SECTION 009113 – ADDENDUM TWO

- A. Project Name: 21098.01 New Albany Center for Innovation Phase 1
- B. Owner: New Albany Schools, 1112 Wesson Tate Drive, Mississippi 38652
- C. Architect: Dale | Bailey, an Association, One Jackson Place, Suite 250, 188 East Capitol Street, Jackson, MS 39201
- D. Architect Project Number: 21098-01
- E. Date of Addendum Two: 28 February 2023

C-11.0

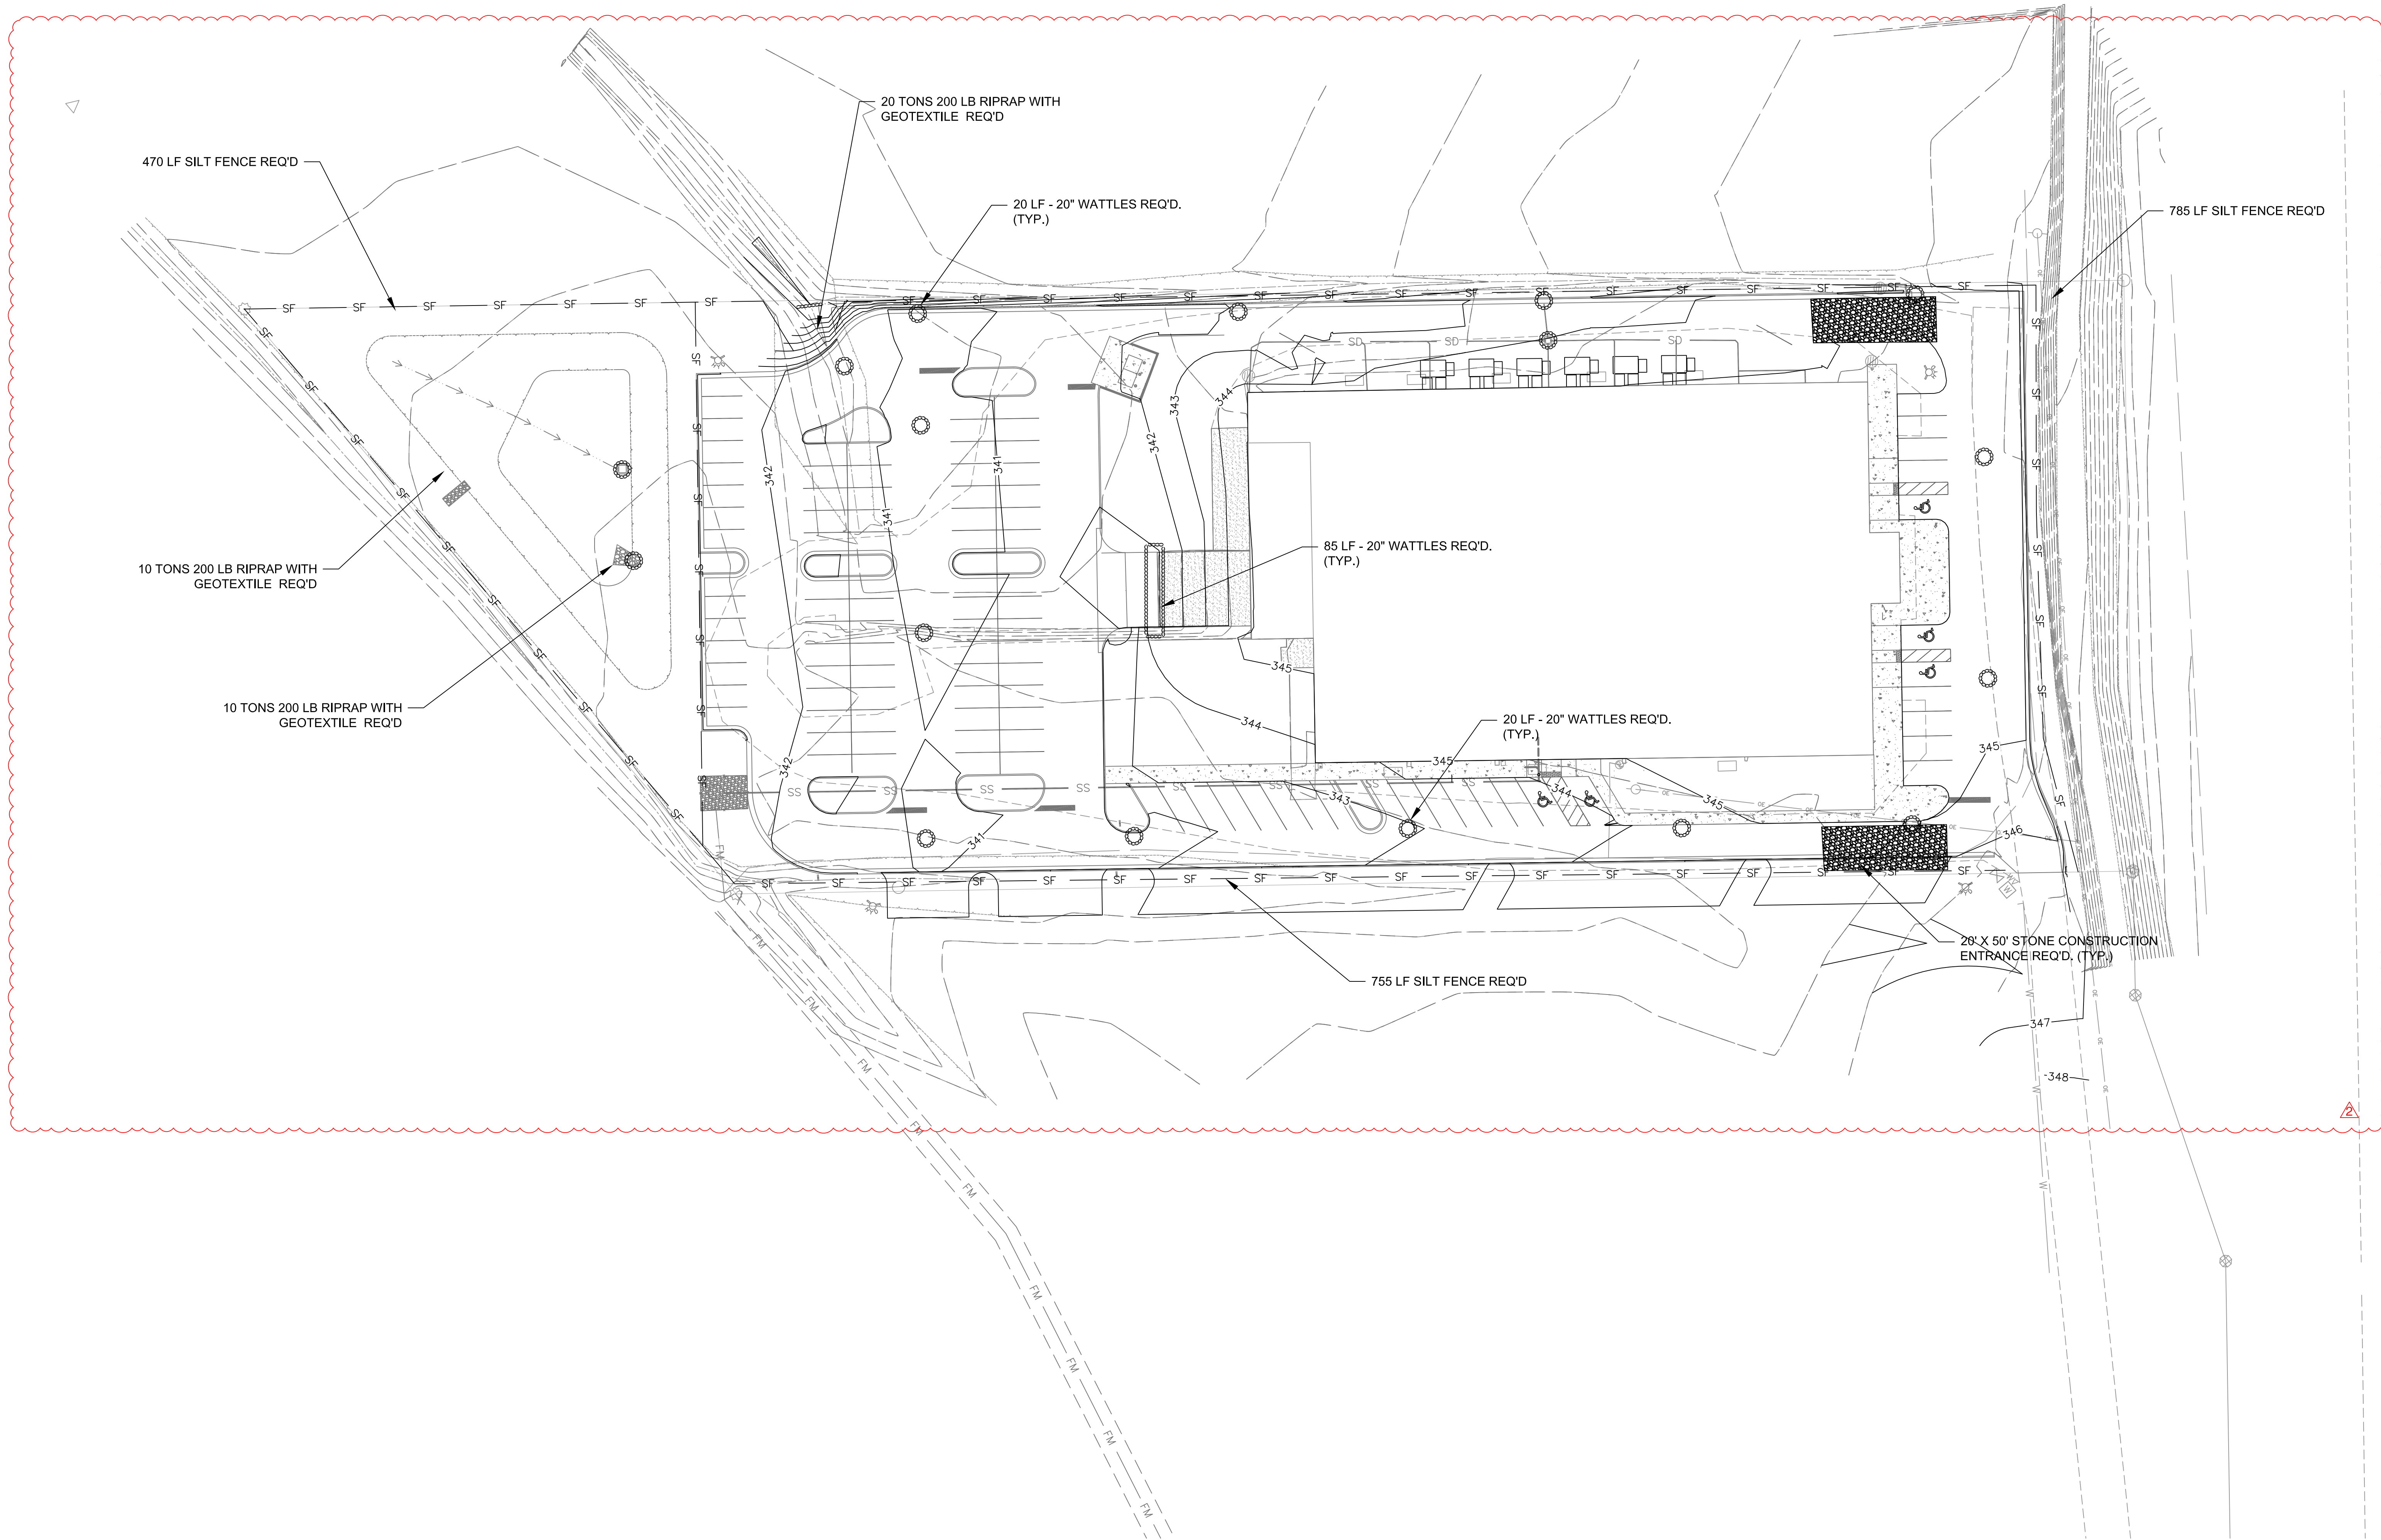
- J. Sheet C11.0 – EROSION CONTROL. Updated erosion control plan to match revised site plan. See attached.
- K. Sheet F-001 – Phase 1 – FIRE SPRINKLER NEW WORK PLAN. (REISSUED). Delete this sheet in its entirety and replace with attached. Revised sprinkler layout to include overhang and storage room.
